Subject: Implementing ultra-precision flat carrier tape and updating pressure seal tape

PCN #: PCN-01452

PCN Number: PCN-01452		PCN Date: July 9, 2021													
Title: Tape and reel carrier tape change															
Proposed first Ship Date: July 2020		Estimated Sample Availability/Qualification Completion:	On request												
Proposed last Ship Date:															
Change Classification: Major <input type="checkbox"/>		Minor <input checked="" type="checkbox"/>													
Change Type:															
Assembly Site <input type="checkbox"/>	Design <input type="checkbox"/>	Electrical Specification <input type="checkbox"/>													
Test Site <input type="checkbox"/>	Assembly Process <input type="checkbox"/>	Mechanical Specification <input type="checkbox"/>													
Test Process <input type="checkbox"/>	Assembly Materials <input type="checkbox"/>	Packing/Shipping/Labeling <input checked="" type="checkbox"/>													
PCN Details															
Description of Change:															
<p>The carrier tape is being converted from to a slightly larger pocket and from a 2mm to 4mm pitch for the pockets. Dimensions and shape for carrier tape changes are shown below.</p> <p>F

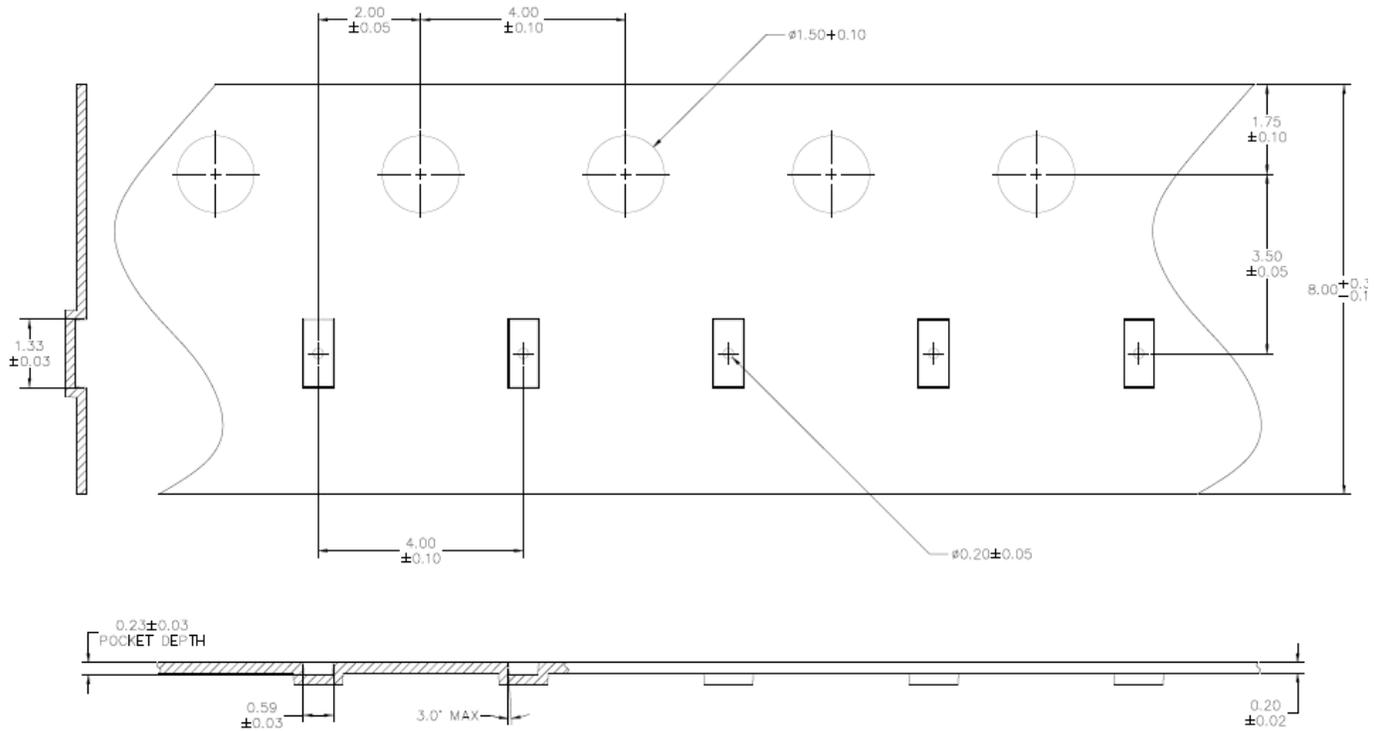
Minimize the die out of pocket and the die sticking to cover tape due to mechanical adhesion and for ease of assembly.
